Studebaker

SERVICE BULLETIN

NO. 277

1953

FIG. 5

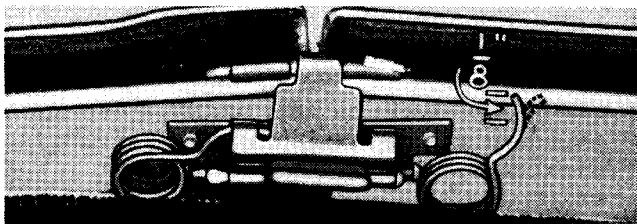
It is possible on some 1953 Hard-Top models equipped with the flipper-type door opening upper weather seal that the forward end of the forward hinge spring may disengage from the clip on the hinge.

To correct this condition on the car, bend a hook (see dotted line in Fig. 5) at the end of the disengaged spring as follows:

With a pair of needle-nosed pliers, grip the loose part of the spring about 1/8" from the end. Next take a pair of standard pliers and bend the end of the spring about 1/8" in a direction opposite to its normal direction. This forms the hook. Use the needle-nosed pliers to insert the spring hook so that it extends through the hinge and prevents recurrence of the condition.
